FINAL CLOSURE & RECLAMATION PLAN
BLAZON No.1 MINE

CARBON COUNTY, UTAH

Re: Response to July 25, 1985 Technical Review Questions
Final Reclamation of Blazon No. 1 Mine

Figure 1
RECLAMATION SCHEDULE

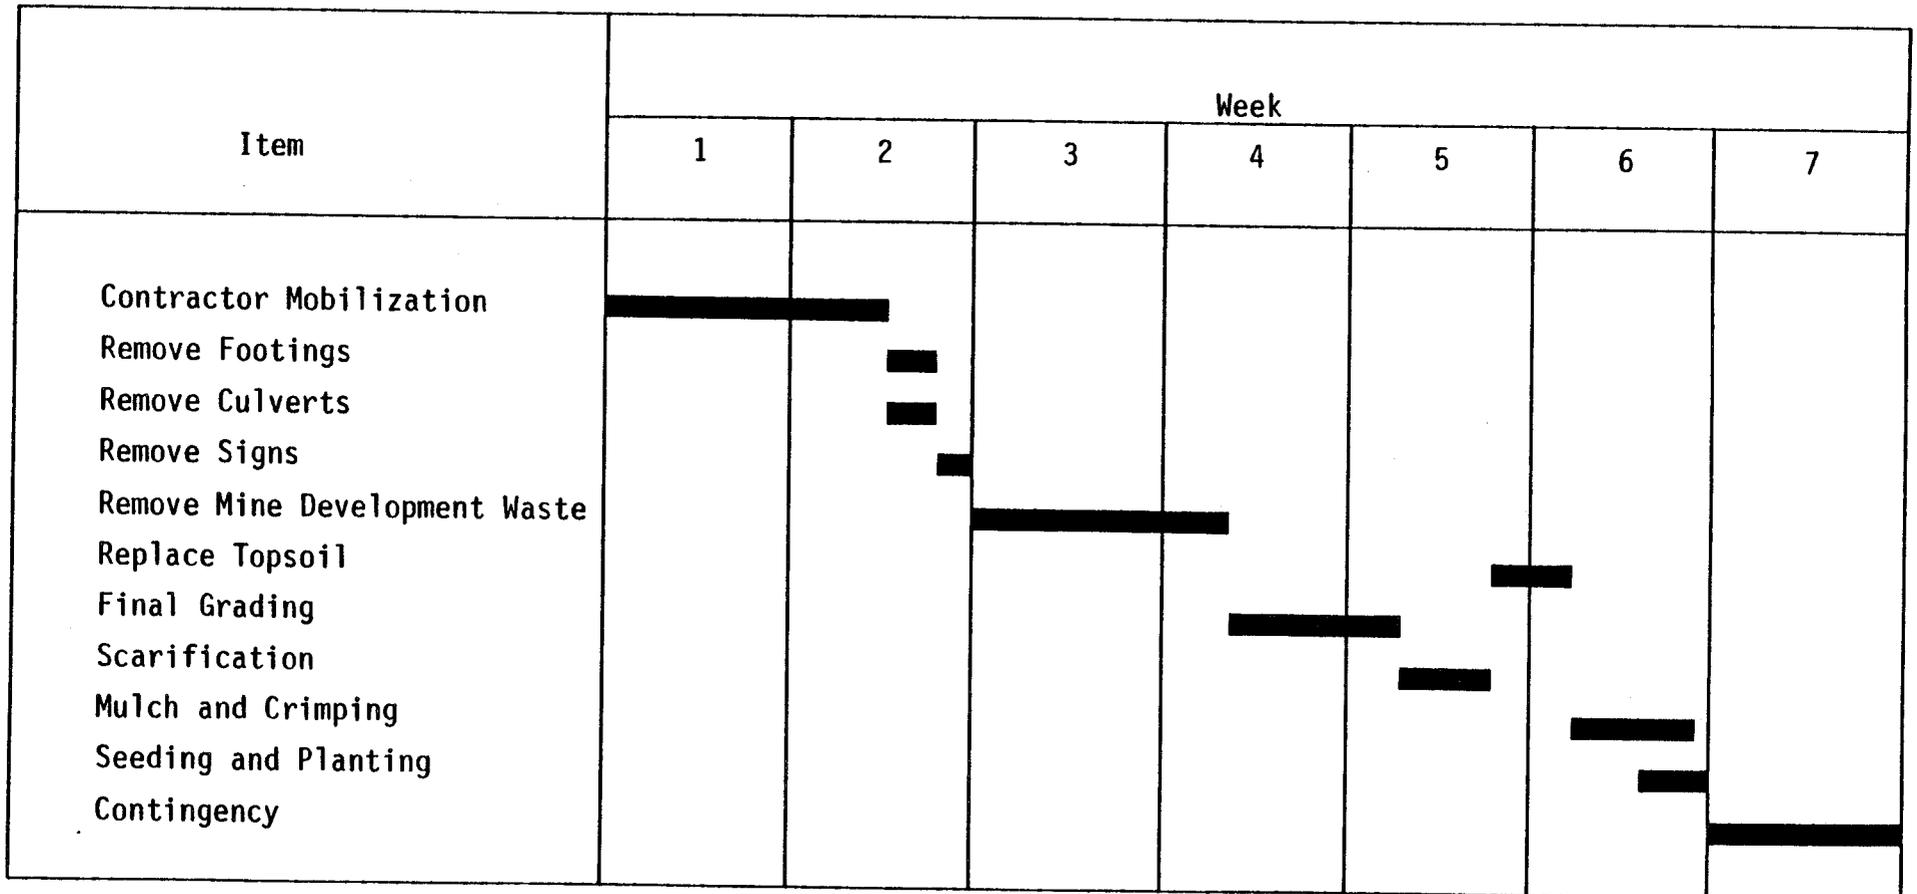
(b)(1) The applicant has not provided a schedule for the reclamation of the lands within the proposed permit area. The reclamation plan requires a detailed timetable of each major step in the reclamation plan. This can be accomplished by providing a bar chart on a weekly schedule for the reclamation construction. Timing can be accomplished by notifying the Division within 30 days of commencement of the reclamation construction work.

Response: North American Equities ("NAE") had previously submitted a reclamation schedule to the Utah Division of Oil, Gas and Mining ("UDOGM") in Exhibit 4 and on page 32 of the previously submitted Reclamation Plan dated May 29, 1985. Exhibit 4 is March 23, 1985 letter from Alan Smith of NAE to Ron Daniels of UDOGM regarding permanent closure of the Blazon No. 1 Mine.

In order to further clarify the reclamation schedule, NAE has attached Figure 1, Reclamation Schedule, to provide UDOGM with a more specific schedule. We have hesitated to put exact dates on the schedule as we are unsure as to the timing of approval by UDOGM; however, we have blocked out reclamation activities by week. In addition, we plan to begin immediate reclamation work upon approval by UDOGM.

Culvert A Channel Restoration

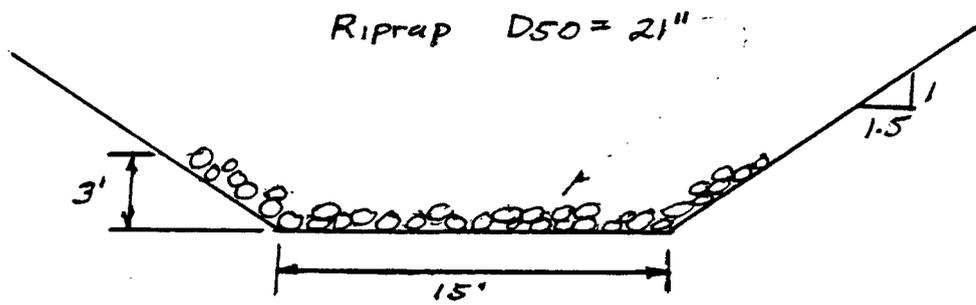
The applicant must include plans for the reclamation of the channel bank after the removal of the culvert. These plans must include recontouring of the bank and design for rip rap protection. The applicant must also state when the culvert will be removed. Figure 1 in the August 8, 1985 correspondence from NAE indicates the culvert will be removed prior to any grading or seeding. The response to UMC 817.44(c) on page 14 indicates that the culvert will be removed following topsoil and reseeding of the portal bench area. The applicant must also include what time of year the culvert will be removed.

Culvert A will be removed. The channel configuration in the area of the removed Culvert A will be as shown on the Figure 3, Culvert A Channel Restoration. The channel configuration determined for the restored channel in the vicinity of Culvert A was determined from Figure 4, Culvert A Channel Calculations.

RESPONSE: NAE plans to remove Culvert A as shown on the Reclamation Plan Map (Map 2). This culvert is approximately 25 feet in length. NAE plans to gain access across culvert A to the portal for reclamation work. After reclamation work is completed on the portal area, NAE plans to remove culvert A. Thus, culvert A will be removed during the late fall of 1985 following topsoiling and reseeding of the portal bench area. Culvert A channel reclamation is shown on Figure 4, Culvert A Channel Restoration.
